Loxahatchee River District Lift Station #82 Improvements

Addendum Number 1

December 1, 2020

D-1

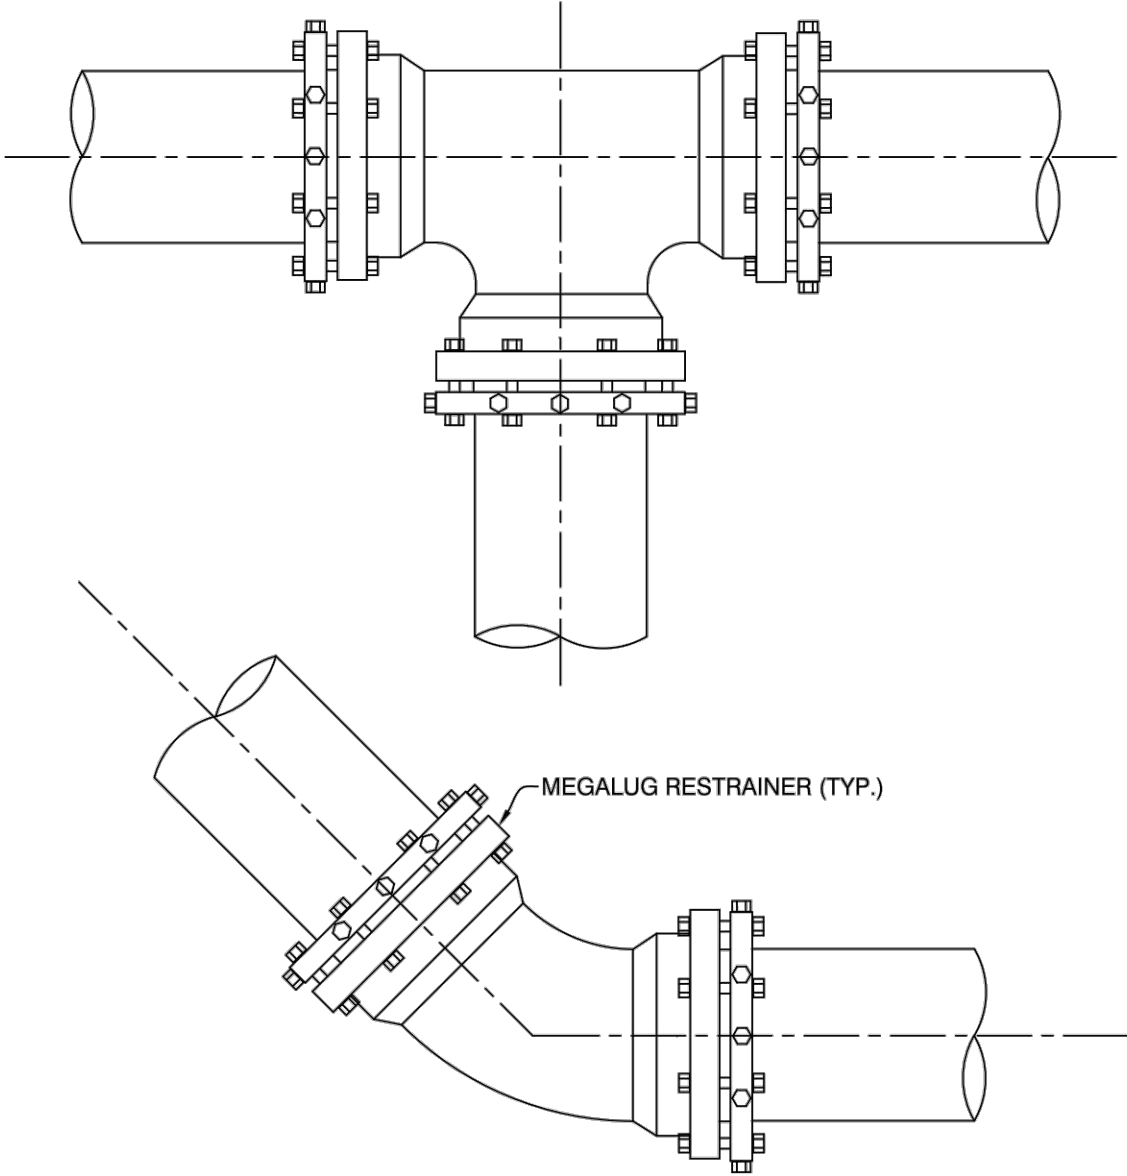
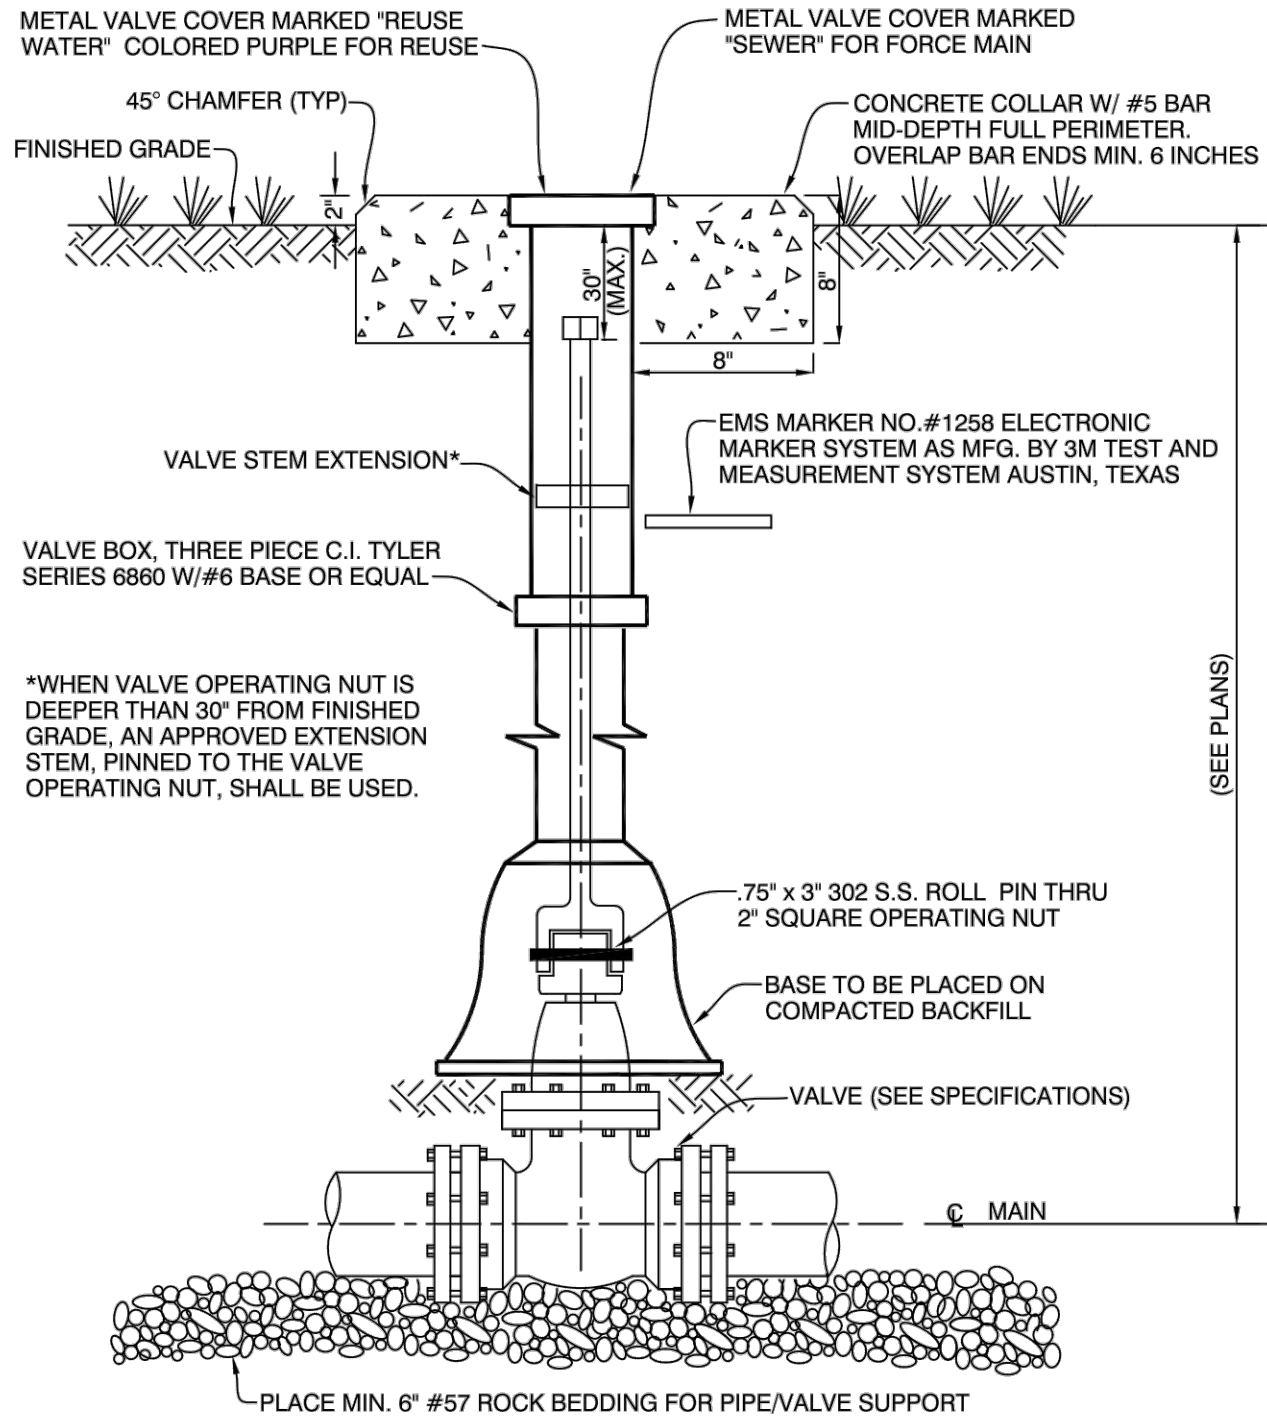
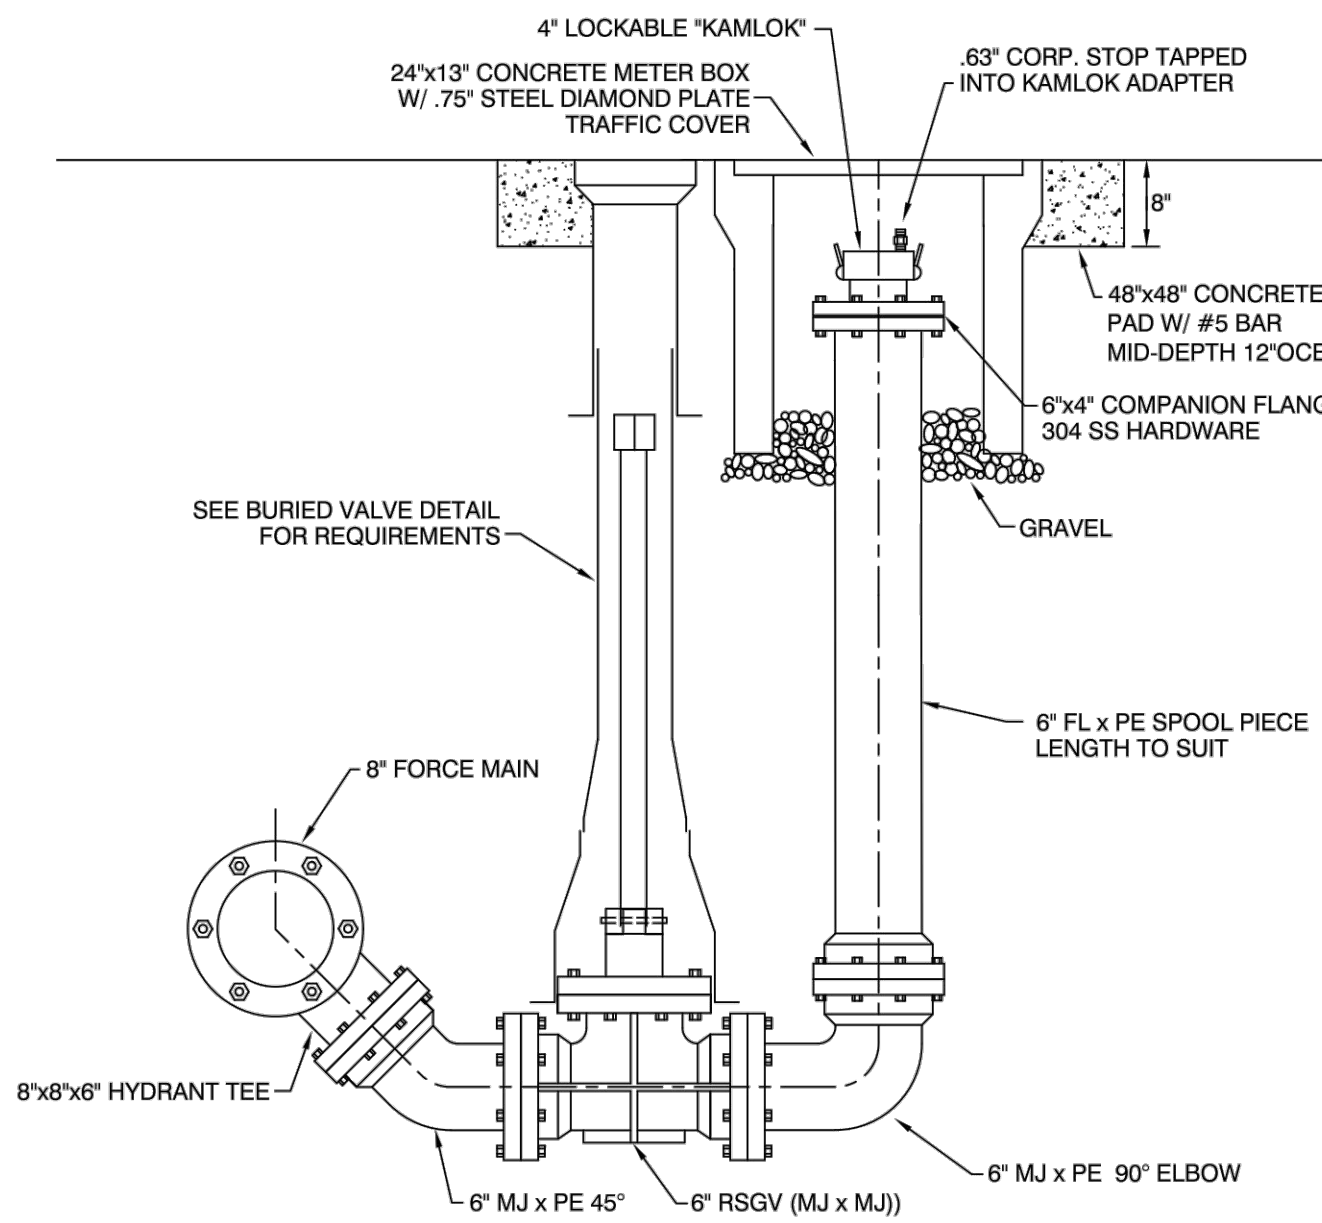
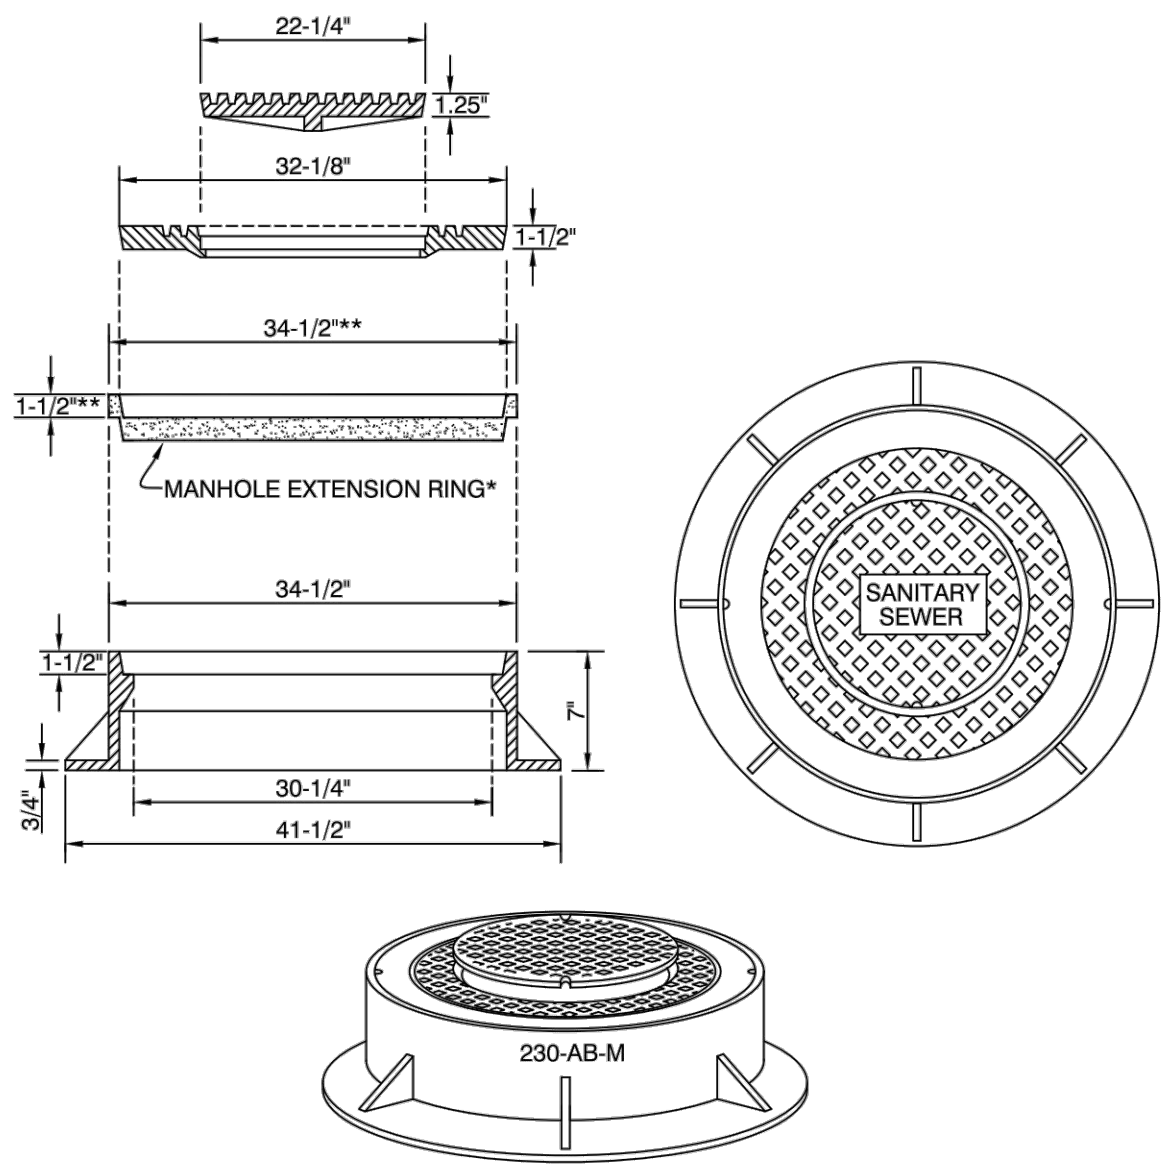
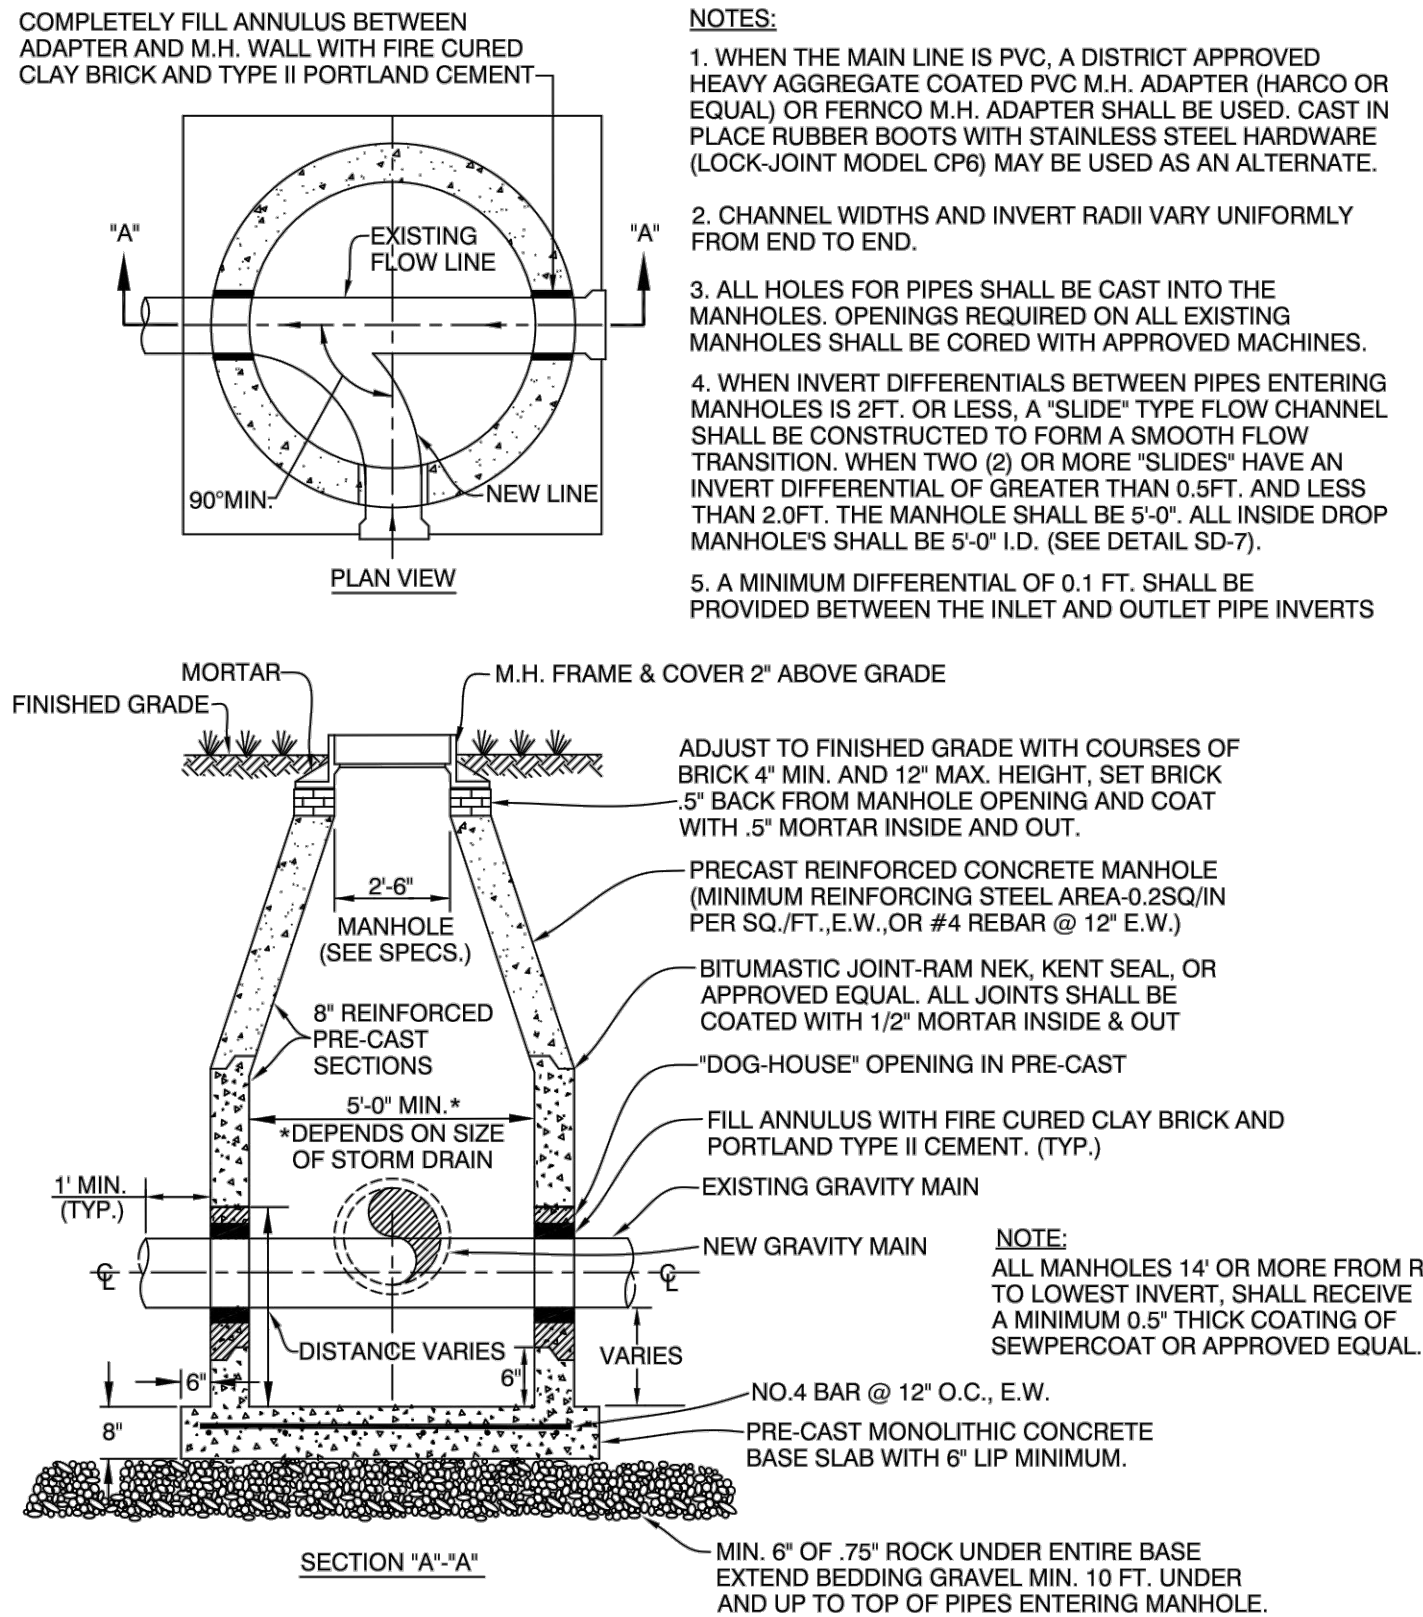
Q1: **Sheet P-1 appears to be missing background pictures for the plan view and the section view and Sheet D-1 has missing or invalid references. Could revised sheets be issued correcting these pages?**

A1: Please refer to the revised Sheets P-1 and D-1.
